**HMC ARCHITECTS
3546 Conours Street
Ontario, California 91764**

Group 7
San Bernardino City Unified School District
Modernization Projects

Bradley Elementary School Modernization - DSA #04-107962	HMC #3137106
Marshall Elementary School Modernization - DSA #04-106227	HMC #3137114
Ramona-Alessandro Elementary School Modernization - DSA #04-106133	HMC #3137117
Ramona-Alessandro Elementary School Interim Housing Port. - DSA #04-110478	HMC #3137117
Bradley Elementary School Deferred Maintenance - DSA #04-110585	HMC #3137206

ADDENDUM NO. 4

SHEET M0.1 DETAIL 6

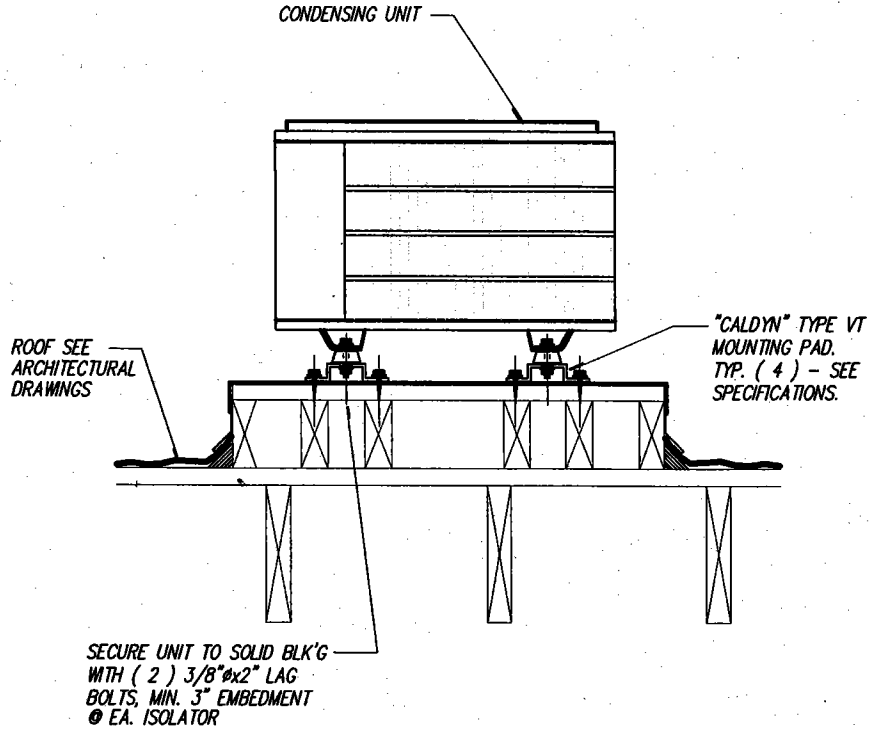
- A. Revise General Note No. 1 to refer to 2007 California Mechanical Code in lieu of Plumbing Code.
- B. Revise Wall Schedule, Refer to Detail A4/A9.2 and 2/S1.2 for (N) non-rated 2x wood stud wall.
- C. Revise Remodel Keynote No. 13. Remove reference to detail, no detail required for installation of batt insulation at underside of roof deck.

AB2.2 - REFLECTED CEILING REMODEL PLAN

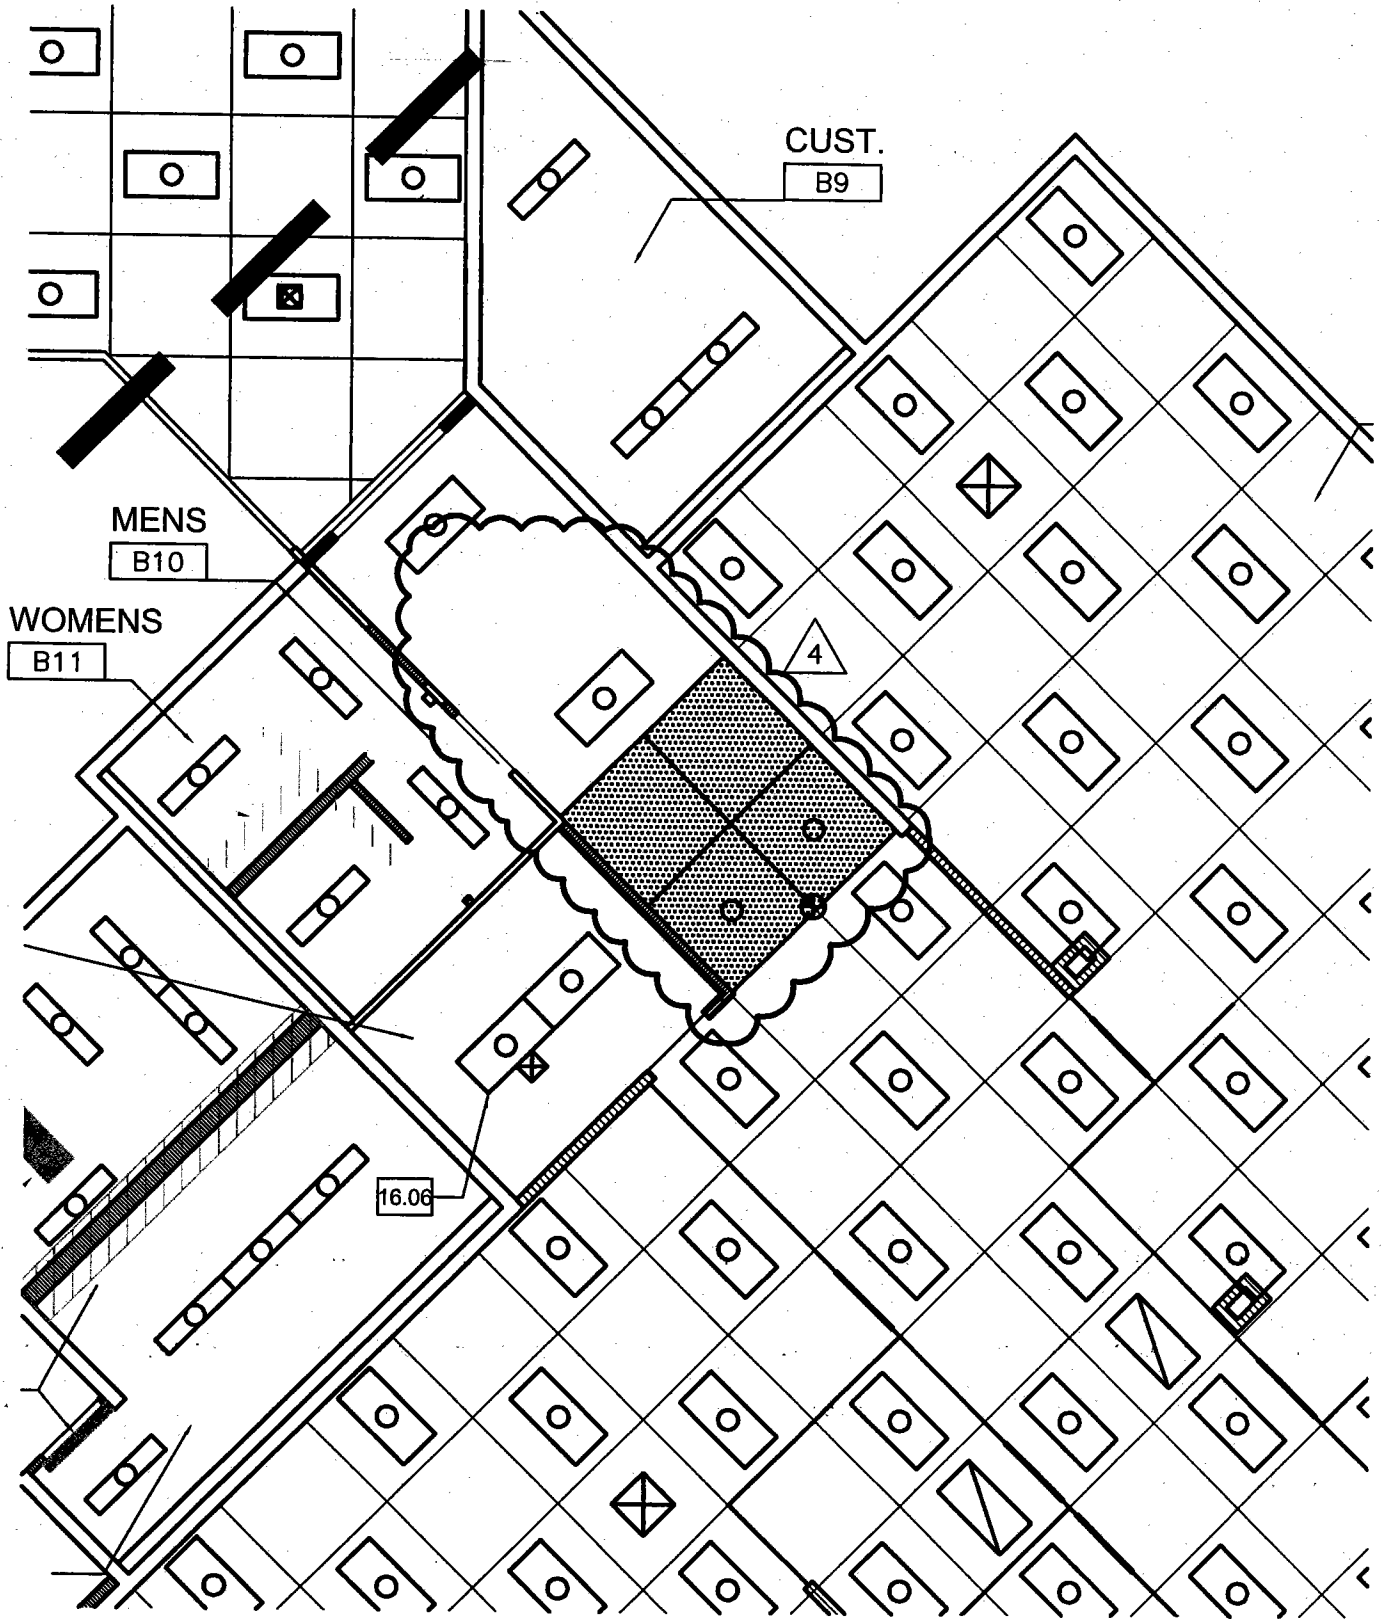
- A. Delete room tags "Wheelchair Lift" at Teacher Prep B12, B6B, B3B.
- B. Add the following general note:

"Contractor to replace and finish areas of ceiling as necessary for the removal and reinstallation of HVAC Scope of Work elements, Refer to Mechanical Drawings."

Project No. 3137117
Date 3/11/10
Drawing No. AD-4.14

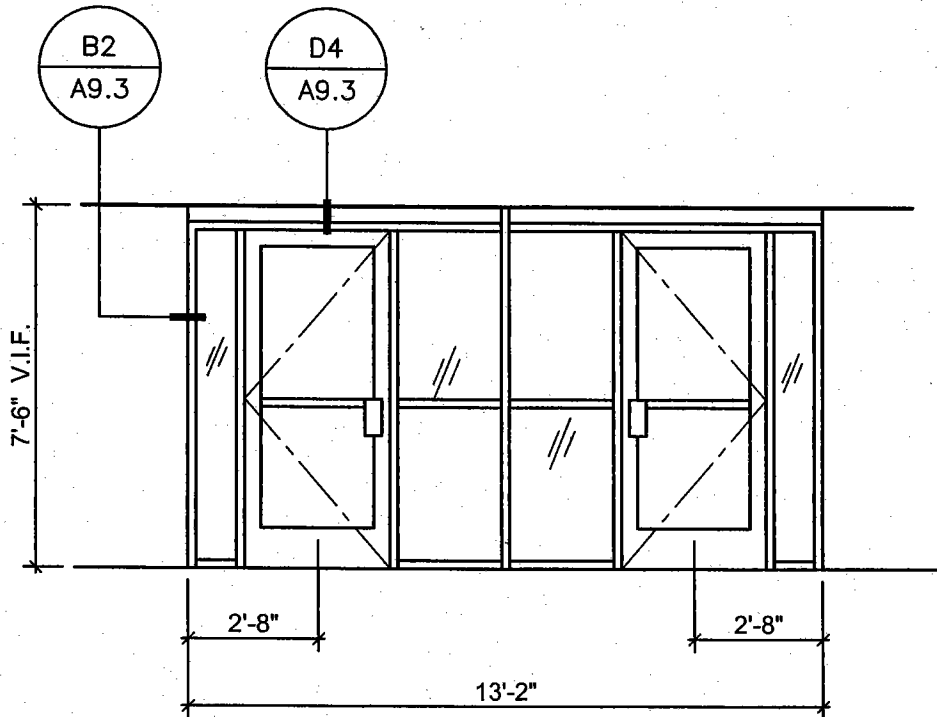
- E. Revise duplicate Door A26a to read as Door A25c. Provide two single full glass doors a new storefront. Coordinate with Detail B6/A4.5, revised per Drawing AD-4.14. Jamb strike and head per elevation and aluminum storefront finishes specification section.

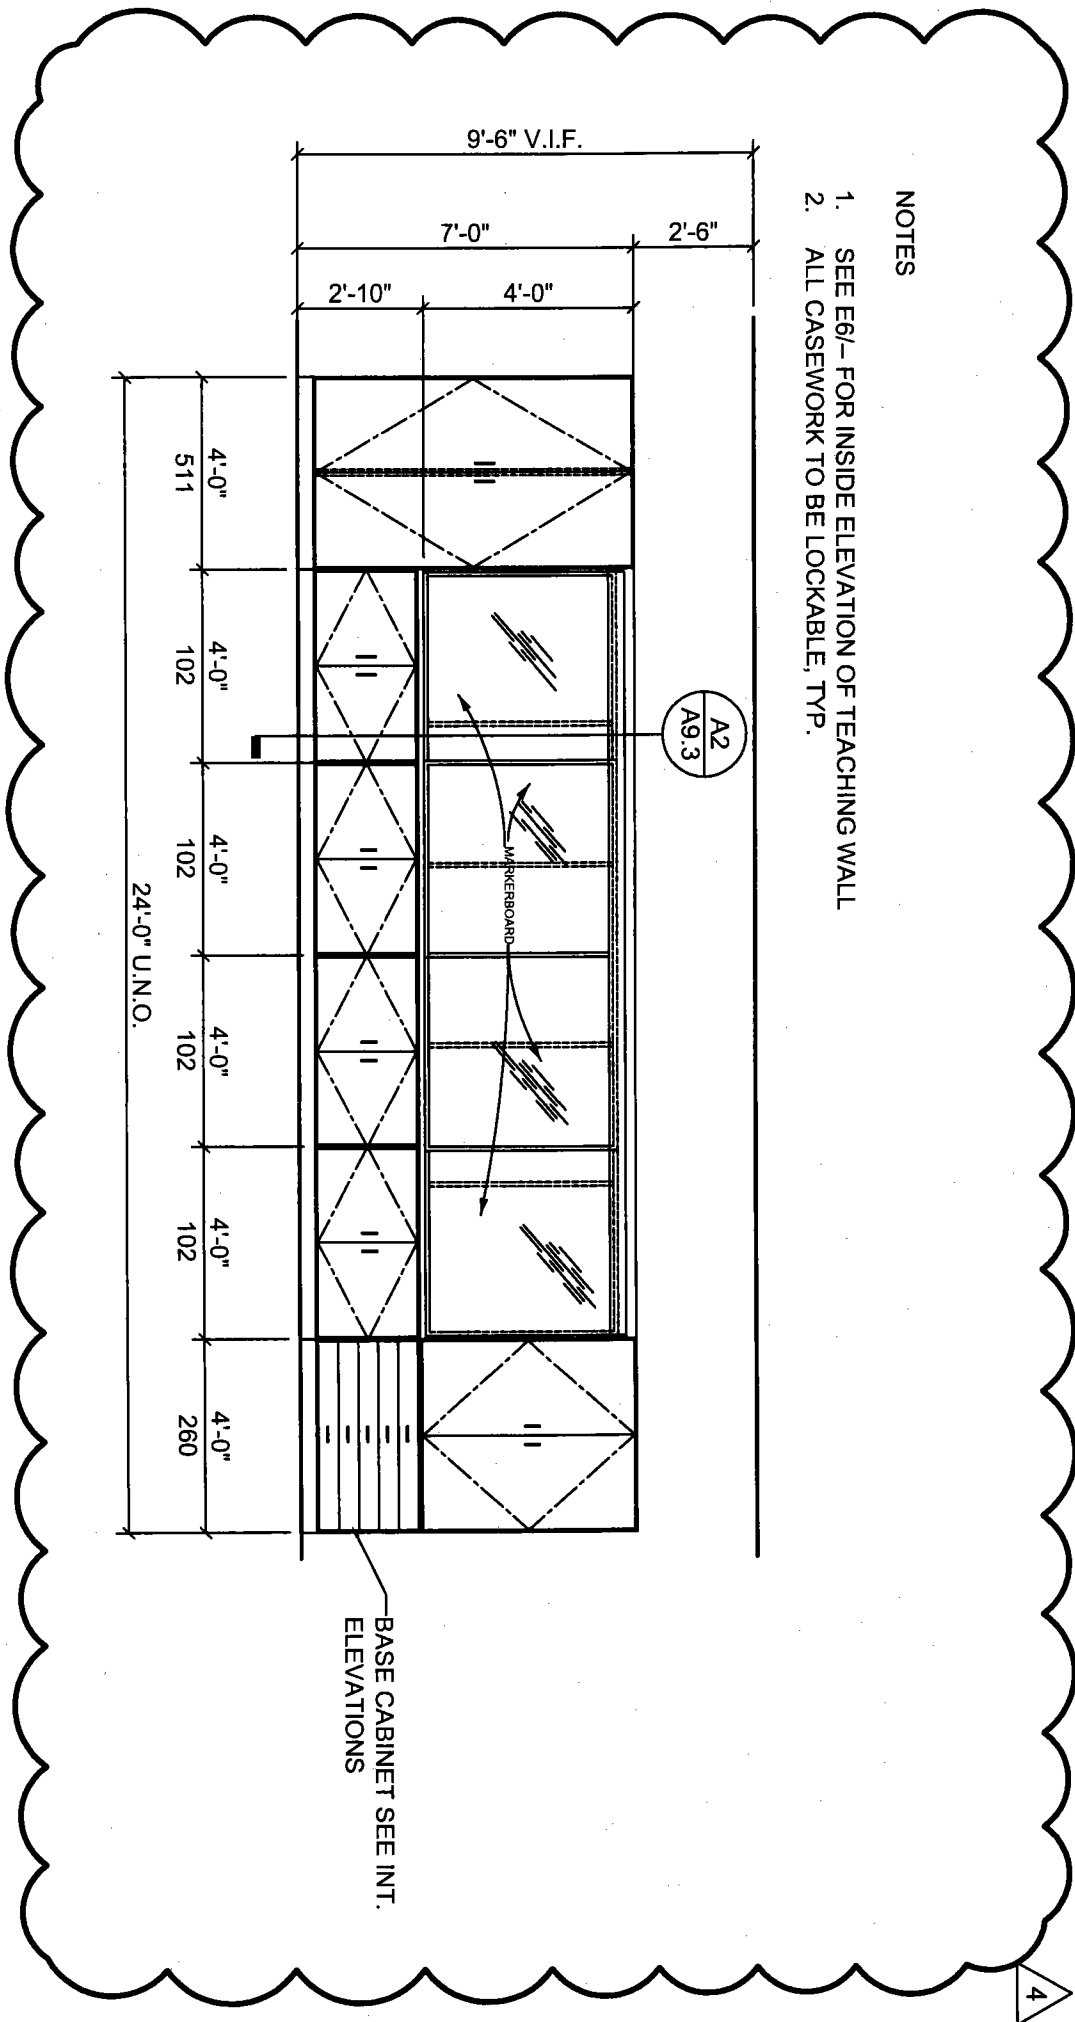
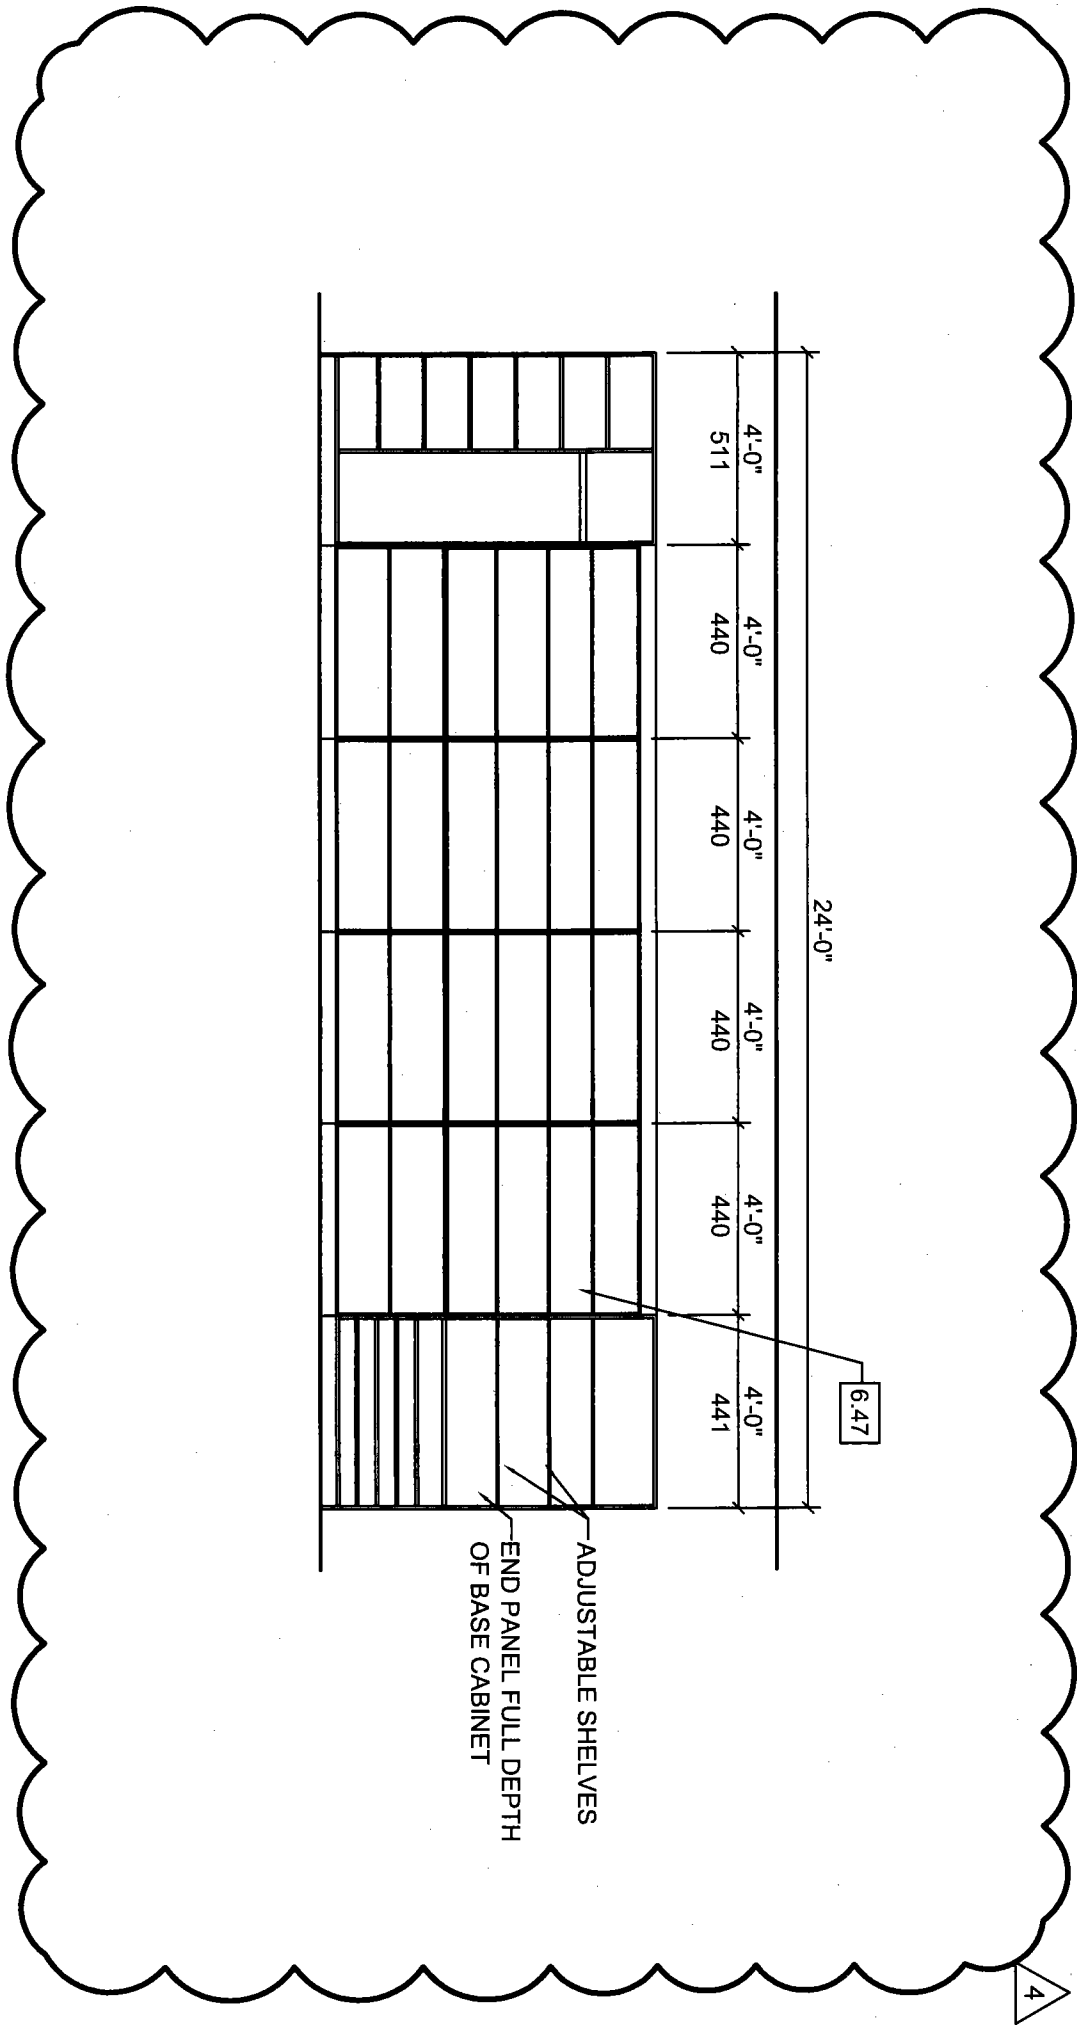
- D. Revise Keynote 9.01 occurring at Flex Room A15 to read as Keynote 9.36.
- E. Provide new 20'-0" long Teaching Wall casework along the North wall of Flex Room A15 as depicted in Addendum No. 4, Exhibits AD-4.06 and AD-4.08.
